Determination 2018/010

Regarding whether proposed barriers to a timber walkway along the shoreline at Mangonui Harbour, Northland will satisfy Clause F4 Safety from falling

Figure 2: Diagram of original proposed barriers to the walkway (not to scale)

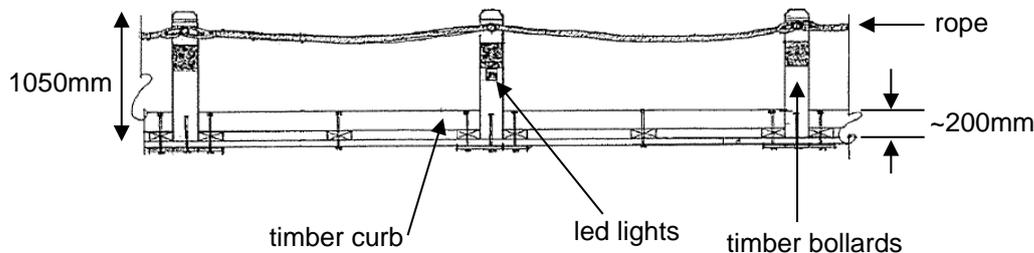
Requirements of F4.3.4, a) to h)	Comments on compliance in relation to the proposed barrier design
(a) be continuous and extend for the full extent of the hazard	The proposed barrier extends the full extent of the hazard.

(b) be of appropriate height	The timber bollards have a height of 1050mm. The height of the rope between the timber bollards is unclear because the rope is fixed below 1050mm, and it will sag even lower between the bollards (the extent to which will depend upon the tension of the rope).

(c) be constructed with adequate rigidity	The timber bollards are fixed into the timber curb with a metal plate. I consider it is likely to be constructed with adequate rigidity and strength.

(d) be of adequate strength to withstand the foreseeable impact of people and, where appropriate, the static pressure of people pressing against them	
(e) be constructed to prevent people from falling through them	This will be satisfied by the use of the rope that is hung between the bollards, which will have adequate strength to prevent somebody breaking through the rope or bollard.

(f) [Revoked]	-
(g) restrict the passage of children under 6 years of age when provided to guard a change of level in areas likely to be frequented by them	There are gaps of approximately 650mm between the timber curb and the rope that will not restrict the passage of children.

(h) be constructed so that they cannot readily be used as seats	The size of the timber bollards is not clear from the drawings provided. However, the tapered edges of the bollard and small circumference of rope do not lend themselves to be easily used as seats. I note the existing timber bollards can be used as seats.

5.3.3 The proposed design does not comply as an alternative solution with the requirements of Clause F4.3 with respect to F4.3.4(b) and (g).

- 6.1 In accordance with section 188 of the Building Act 2004, I hereby determine the original and modified barrier designs do not comply with Clause F4 of the Building Code.

Figure 3: Diagram of modified barriers to the walkway (not to scale)

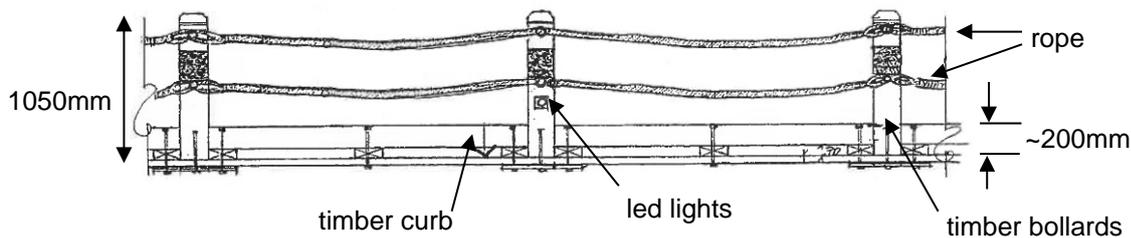
5.3.4 The authority provided a modified design it believed would comply with Clause F4.3.4(g). The modified design proposed an additional rope, visual alerts (signage and led lighting), combined with adult supervision to restrict the passage of children under 6 years old.

5.3.5 It is clear gaps of 300mm will not restrict the passage of children. The inclusion of the additional rope, while reducing the gap, still leaves about 300mm each side of the

rope between the timber curb and top rope. The lighting and signage, while providing a visual alert regarding the change of level, does not restrict the passage of children under 6 years old.

5.3.6 The commentary in F4/AS1 notes horizontal elements are climbable by children who are 2 years or older. I consider the horizontal ropes, depending upon the level of tension, could be climbable by a child.

5.3.7 In regard to the supervision of children, the level of supervision required to prevent a fall is not sustainable. Also, supervision would not necessarily prevent injury even if the child was rescued after passing through the barrier. The performance requirement of Clause F4.3.4(g) recognises children are less aware of the risks posed by an accidental fall. The functional requirement of Clause F4 reflects the intent that the Building Act does not cover management/supervision practices. Adults and older children can have different attitudes to the risks present from the walkway and varying levels of supervision that would be required to prevent a fall. This is why the functional requirement requires buildings to reduce the likelihood of an accidental fall, rather than relying on management to safeguard from injury.

5.3.8 The modified design does not comply as an alternative solution with the requirements of Clause F4.3 with respect to F4.3.4(g).
